Interactive comment on “Runoff regime estimation at high-elevation sites: a parsimonious water balance approach” by E. Bartolini et al.

Received and published: 15 April 2011

Fig. 1. MAE variability depending on the values assumed by SR and the melt coefficient c. a) local scale application, sigma=4°C; b) regional scale application, sigma=3°C (River Evancou at Champoluc).

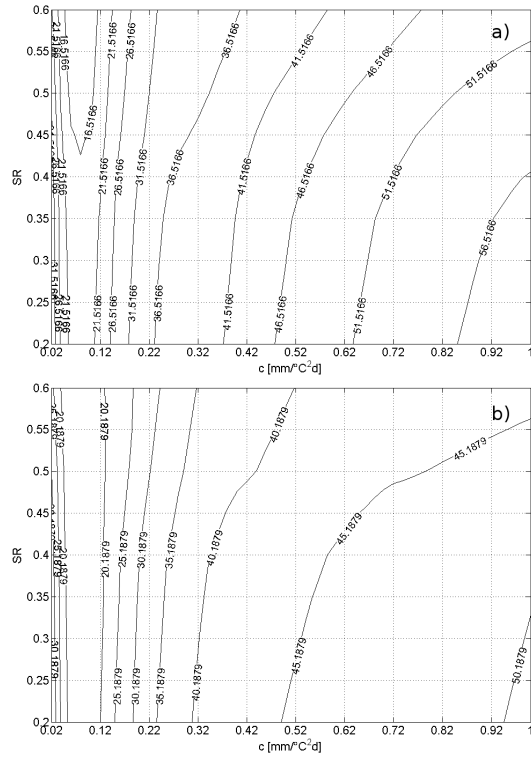
- 2 The authors make an argument in the discussion section that the second parameter is justified based on the improved model performance by including that parameter. However, no justification is made for not including some processes and parameters that may be very important. The most obvious example is the decision on whether or not to include soil moisture storage and associated parameter(s). It is possible that an additional parameter related to soil moisture storage and release may be as important as or more important than the second snowmelt-related parameter that was included. This should be tested. Not including soil moisture storage dynamics is a major weakness in this model that deserves more attention.

The model partially accounts for the effects of soil storage through the coefficient SR of storm runoff. In fact, this variable represents the fraction of precipitation that directly contributes to surface runoff, while the remaining precipitation is theoretically available for infiltration and constitutes the storage for evapotranspiration. As a consequence, a preliminary assessment of the role of the soil moisture storage is in Fig. 8b (P990) where the results with SR=0.3 are compared to those of a model with SR=0. Since the MAEs associated to the model with SR=0.3 are generally smaller than the ones with SR=0, we concluded that the assumptions made were adequate.

In the model, SR was not considered as a parameter to be calibrated, but as a fixed value, valid for the whole region. This value has been obtained as a result of several considerations. We initially considered SR as a third parameter to be calibrated, and varied it in the interval 0.2-0.6 with steps of 0.05. This formulation of the water balance model, characterized by the presence of three parameters (σ , c and SR), has been applied both at the local scale and at the regional scale. Analyzing the variability of the MAE on the parameter values, it was found that the MAE remains almost constant for changes in SR, both for the regional application of the water balance (see Fig. 1b of this reply) and for the local-scale application (see Fig. 1a of this reply), in the large majority of catchments. For this reason, we decided to consider the storm runoff as a fixed value, also considering that the regional parameter calibration returns a value of SR for the entire region equal to 0.3.

Fig. 2. Effects of the elevation-dependent variability of the average temperature regime on the Thornthwaite potential evapotranspiration

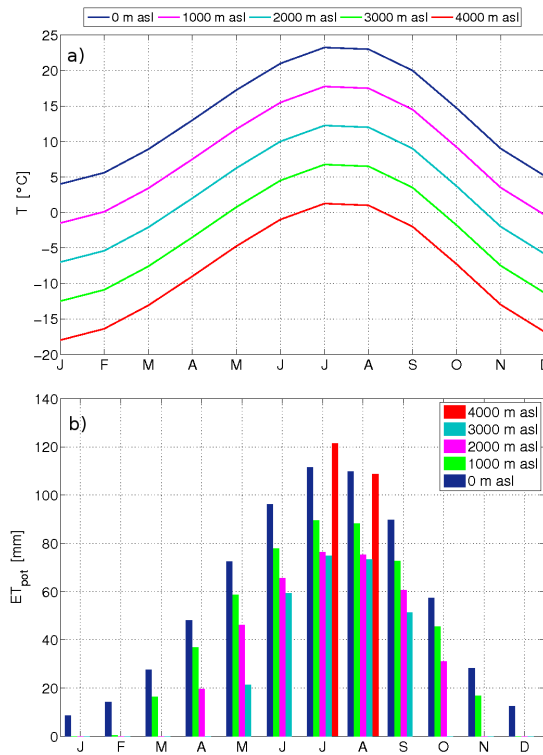
P965L6: “heat indices are supposed to take on values greater than 5” – is there a reference for this fact?

No, there is no reference for this. As mentioned in the paper, we found that the application of the Thornthwaite equation for high-elevation cells leads to an overestimation of potential evapotranspiration due to the values assumed by the heat indices. To demonstrate this effect, the average monthly temperature regime of the study domain at the sea level has been translated, by applying a fixed lapse rate equal to -5.5° C/km, at different elevation, namely 1000, 2000, 3000 and 4000 m asl (Fig. 2a). For each case, the indices I, a and the monthly potential evapotranspiration are computed. Figure 2b shows that, during summer months, the potential evapotranspiration simulated at 4000 m asl is equal or even larger than the one simulated at the sea level, even if the monthly temperature is significantly lower. This problem can be solved imposing that evapotranspiration continues to decrease also at higher elevations, as actually happens in real conditions. This condition is met by imposing that the heat index can take only values greater than 5.

Fig. 3. Mean basin precipitation, P, temperature, T, and runoff, R_obs, observed regimes: a) Savara at Eau Rousse; b) Sesia at Ponte Aranco; c) Rutor at Promise; d) Toce at Candoglia.

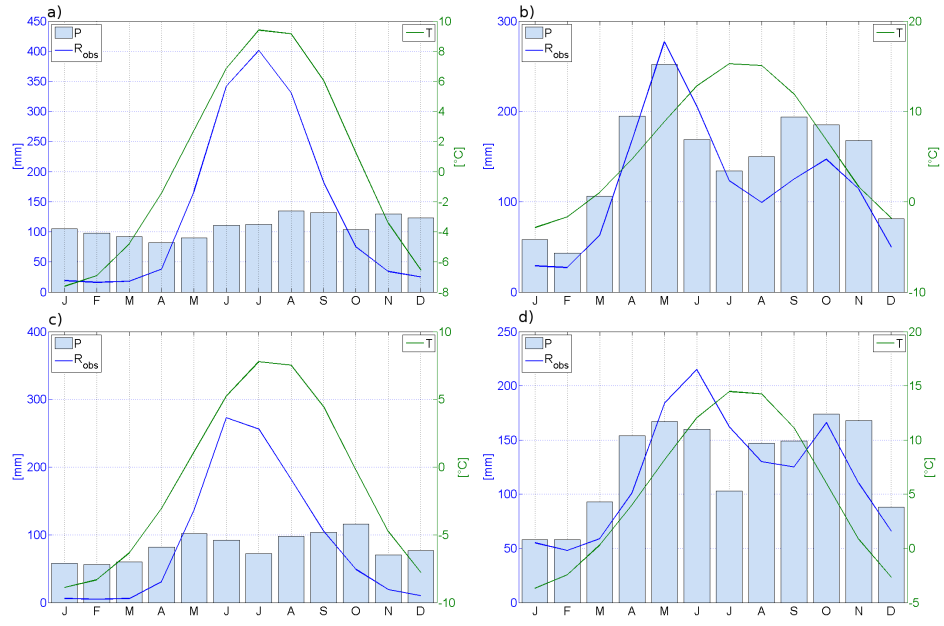
It would be good to show monthly plots of precipitation and temperature, either on average over the case study region, or by basin, as in figures 5 and 6. This would help readers who are not intimately familiar with these basins in interpreting the results.

The possible introduction in the paper of an additional figure showing the seasonality of the other variables involved in the water cycle has been raised also by the anonymous referee 1. However, due to the length of the paper, we believe that this would not be the right choice. At the same time, we are aware that some additional information on the climatology of the basins inside the study region could be really helpful for readers that are not familiar with this area. For this reason, we introduced the figure suggested by the referee here in the public discussion and we will recall it in the revised manuscript. In this way, it will always be publicly available.
